LIFTING EYE

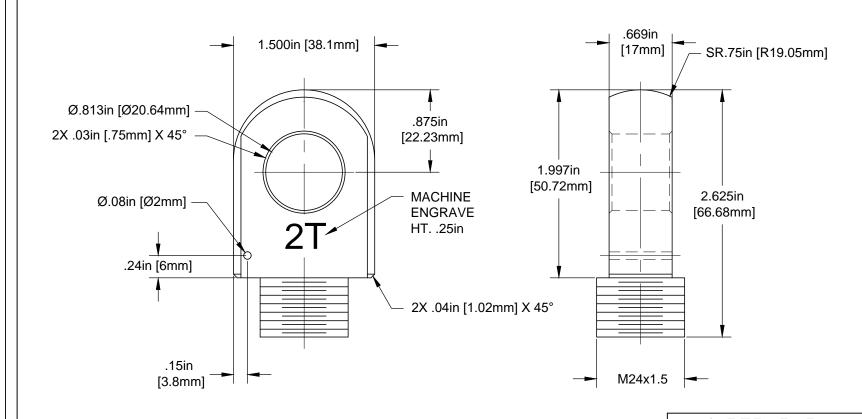
REVISIONS				
REV	DESCRIPTION	DATE	INITIAL	APPROVED
2	DELETED RB MACHINE LABEL FROM $-5$ , ADDED RED BARN PLACARD TO BOM & $-5$ ASSY DWG, CH'D NOTE $-1$ TO BLACK CUT VINYL STICKER, MOVED $-5$ TO PAGE 3, CH'D HAND STAMP TO MACHINE ENGRAVE P/N $-3$ .	5/20/09	RJC	RW
2B	-3 CH'D CALLOUT WAS M24x1.5 24.511mm OVER .040in WIRES IS M24x1.5, ADDED MISSING DIM 2X .04in [1.02mm] X 45°.	5/30/14	DPD	RJC
